State Water Resources Control Board

EVALUATION OF STAGE I VAPOR RECOVERY COMPONENTS, OPW 61JSK ALTERNATIVE REMOTE FILL CONFIGURATION

Subject: Request for Stage I Vapor Recovery Components,
OPW 61JSK Alternate Remote Fill Configuration for UST Equipment

RE: Third Party Review and Approval of OPW Alternate Remote Fill 61JSK Jack Screw Kit for addition to OPW Phase 1, Executive Order VR-102-L

Alternate Remote Fill Configuration,
61JSK-4410, 4" x 4" x 2" tee

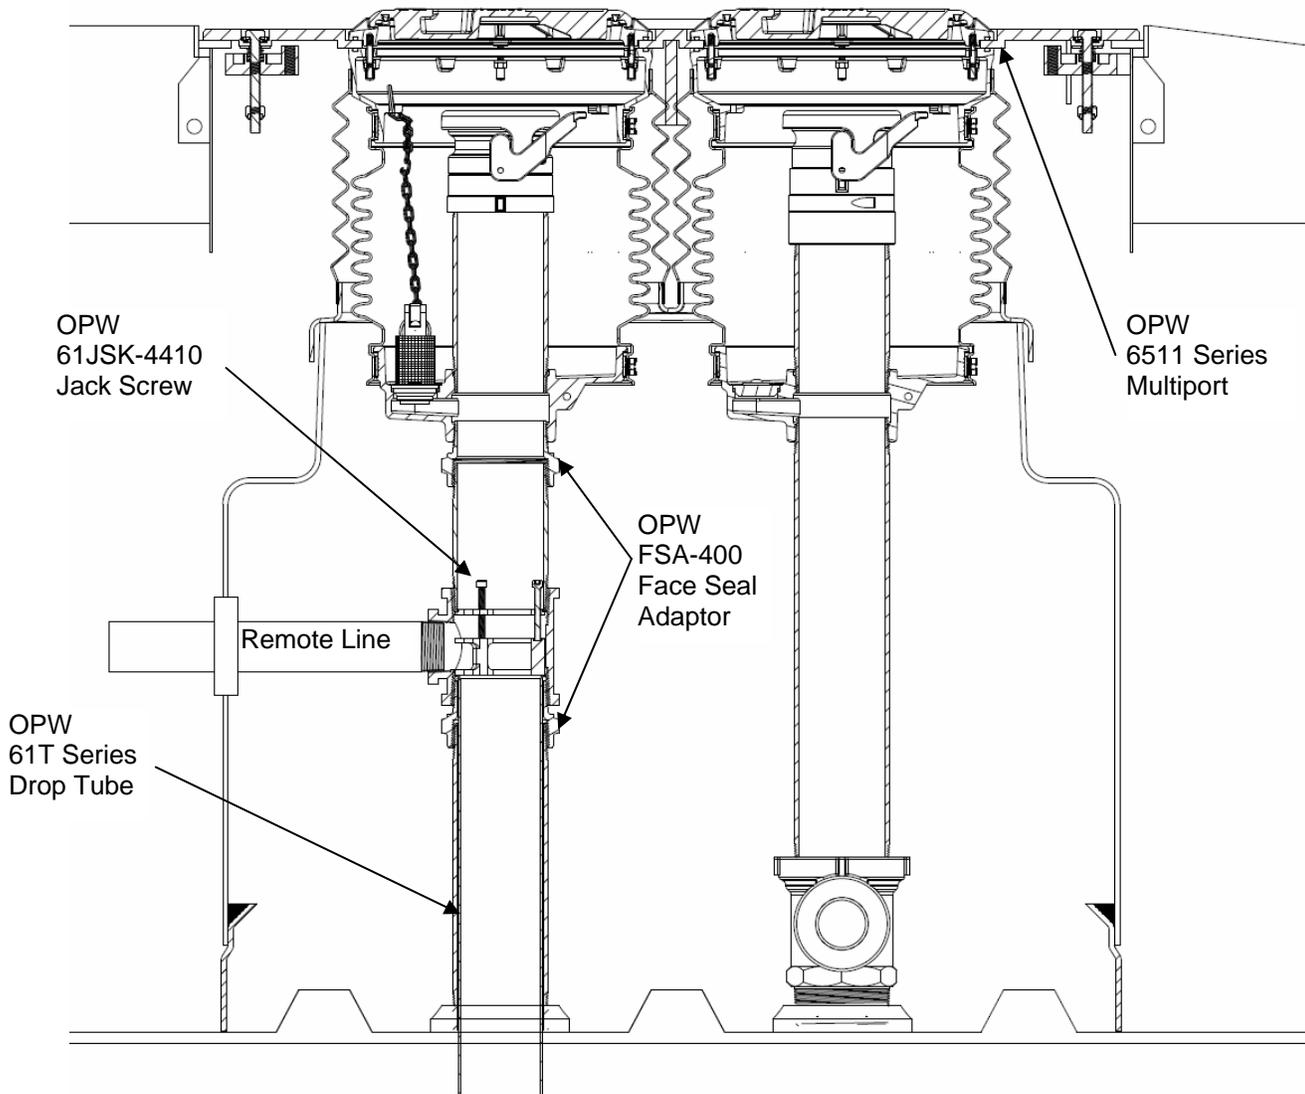
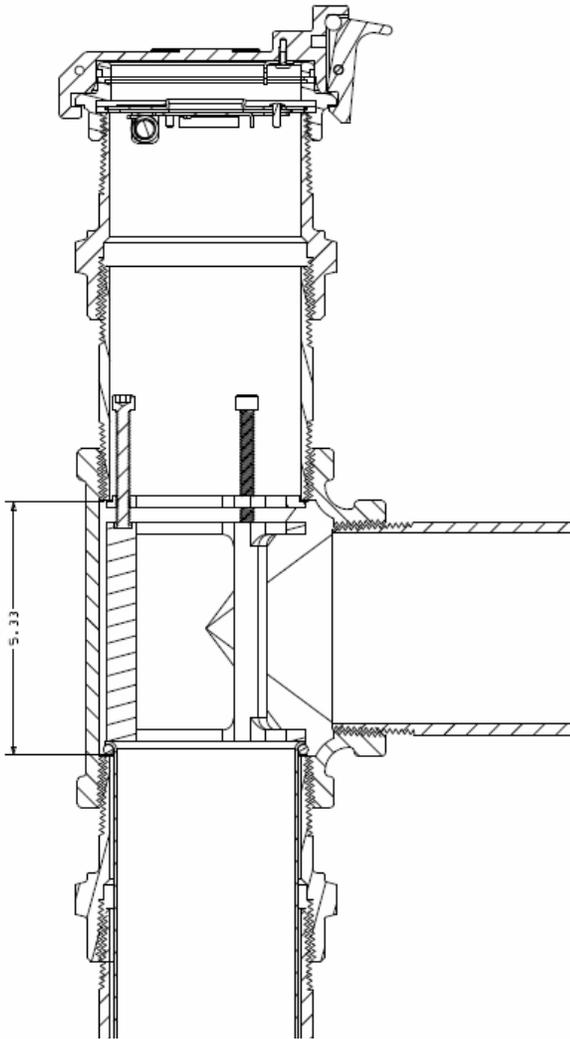
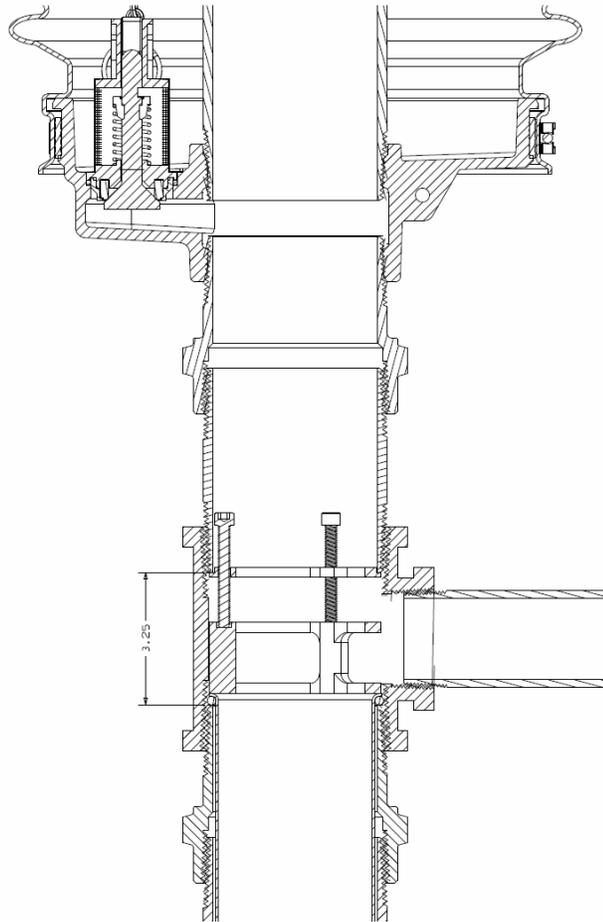
A drawing of the proposed alternate remote fill configuration is shown below:

The following limitations apply to the OPW 61JSK alternate remote fill configuration:

1. Owners or their agents are required to ensure that the space available in the tank is greater than the volume of product to be transferred to the tank prior to each delivery,¹ therefore USTs must include a tank top access port or other method that allows product level gauging prior to delivery.

2. Remote fill piping must be double-walled when connected to any one of the following:
 - A UST system installed on or after July 1, 2003.²
 - A UST system where the overflow prevention valve activates at a level greater than 95 percent.³
 - A UST system where secondary containment of tank fill riser piping is otherwise required by state law or local ordinance.⁴
3. When remote fill piping is required to be double-walled, the requirement applies to ALL remote fill piping components including horizontal-to-vertical transitions and the short vertical piping sections at the tank top and remote fill locations. To achieve this, single-walled piping components at the tank top and remote fill locations must be contained in sumps.
4. A demonstration and verification that the overflow method operates properly may be required by the Unified Program Agency.
